# LiDAR Quality Assessment Report

**MS\_RankinSimpson\_2013**

Fugro EarthData, Inc., as a subconsultant to MGI, LLC was authorized to undertake this project, as a part of Work Order No. 112, dated November 1, 2012, issued to MGI, LLC in accordance with the terms and conditions of the Professional Services Agreement between MGI, LLC and the Mississippi Department of Environmental Quality, dated February 17, 2004. This Light Detection and Ranging (LiDAR) dataset is a survey of the Middle Pearl-Strong River Basin in Rankin and Simpson Counties, Mississippi. The project area consists of approximately 976 square miles. The project design of the LiDAR data acquisition was developed to support a nominal post spacing of 1 meter. Fugro EarthData, Inc. acquired 73 flight lines in six lifts on January 6, 7, 31, and February 1, 2013. The data was divided into 5000 by 5000 foot cells that serve as the tiling scheme. LiDAR data collection was performed with a Cessna 310 twin-piston aircraft, utilizing a Leica ALS60 MPiA sensor, collecting multiple return x, y, and z as well as intensity data. LiDAR data is remotely sensed high-resolution elevation data collected by an airborne collection platf

Checkpoint Distribution Image

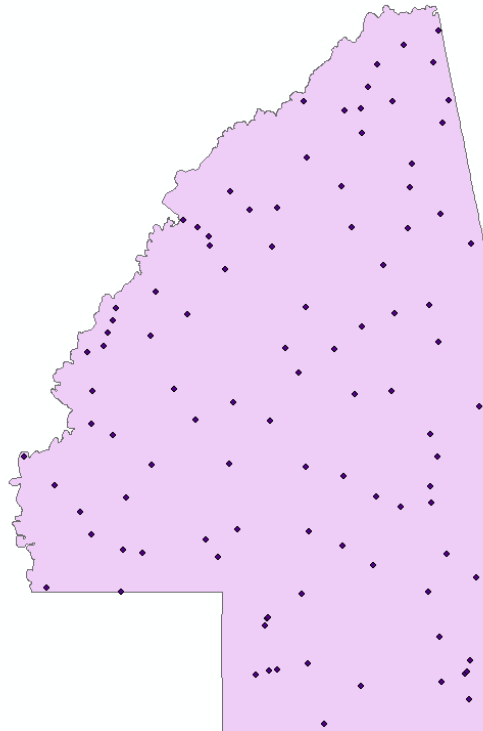
Total number of checkpoints: 100

Reviewed CVA: 0.411 U.S. Feet at the 95 th Percentile
